Index 700-101

Typical Sections for Placement of Single and Multi-Column Signs

COMMENTS AND RESPONSES

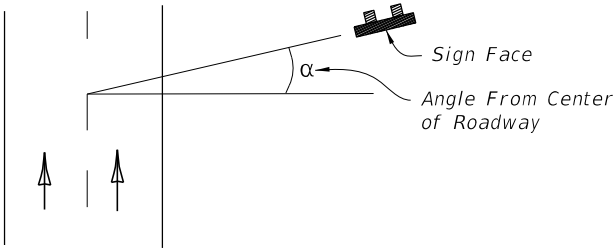
COMMENT: Sidewalk Detail: Since a single-column cantilever ground-mounted sign is shown, the maximum vertical clearance should be 9'-0"', as indicated in the Typical Section on Ind. 700-011, sheet 1 of 2.

RESPONSE: Thank you for the comment. The details for the shared use path and the urban side path will be updated to 8' minimum.

CHANGE MADE TO INDEX: Yes.

LAST REVISION 11/01/25	REVISION	DESCRIPTION:	 FY 2026-27 STANDARD PLANS	TYPICAL SECTIONS FOR PLACEMENT OF SINGLE AND MULTI-COLUMN SIGNS	INDEX 700-101	SHEET 1 of 2
------------------------------	----------	--------------	--	--	------------------	-----------------

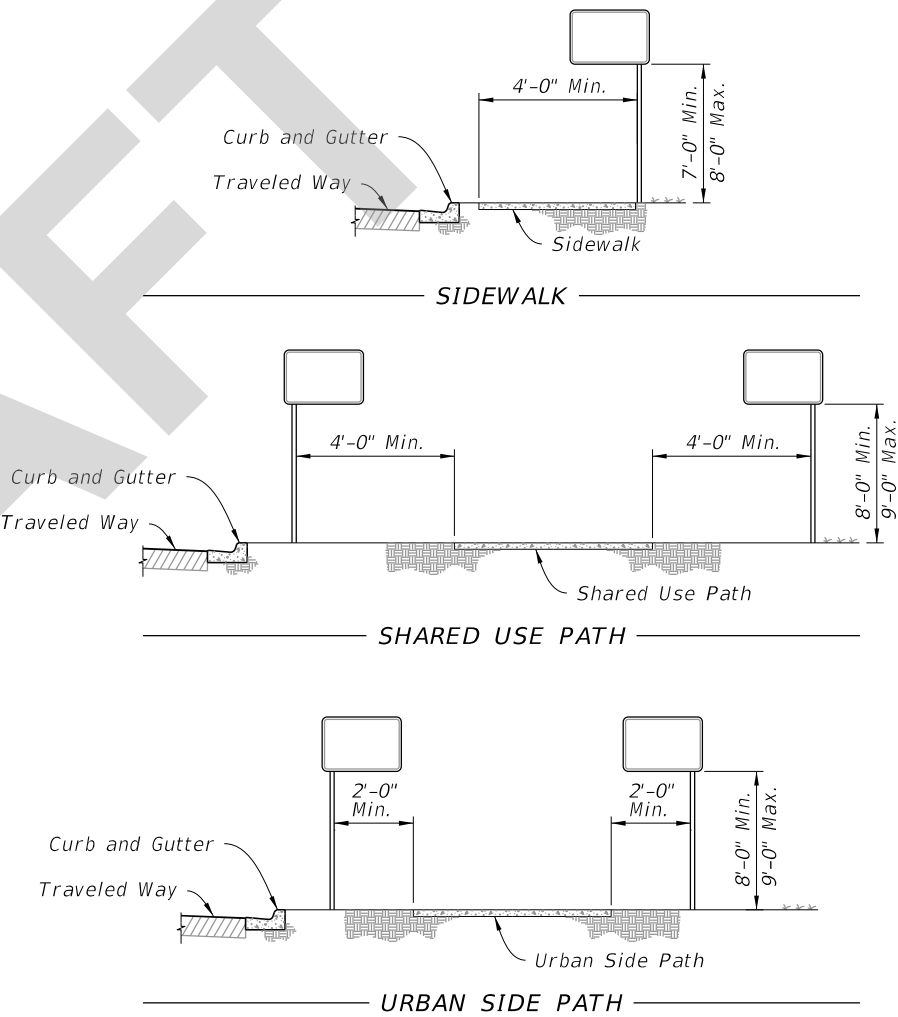
Note 7 does not provide enough information for placing signs along a shared use path or urban side path. Additional language is needed inform proper placement of sign columns along shared use and urban side paths.

COMMENT: Sidewalk Detail: Since a single-column cantilever ground-mounted sign is shown, the maximum vertical clearance should be 9'-0", as indicated in the Typical Section on Ind. 700-011, sheet 1 of 2.

COMMENT: Shared Use Path Detail: Since the SUP is utilized by bicyclists and micro-mobility users, who may off-track, it is recommended to provide a standard vertical clearance of 10' (8' minimum) for sign panels extending over both the SUP and its horizontal clear area. The same consideration should also be applied to Urban Side Paths. Note: if these recommendations are implemented, please update FDM Section 224.8 accordingly.

RESPONSE: Thank you for catching the inconsistency. To stay consistent with the other cases in Index 700-101, we will leave the max height at 8' and revise the max height in Index 700-011 to 8'.

RESPONSE: Thank you for the comment. Currently our requirements state that the minimum clearance should be 8'. The detail will be updated to show this 8' clearance.

CHANGE MADE TO INDEX: Yes.
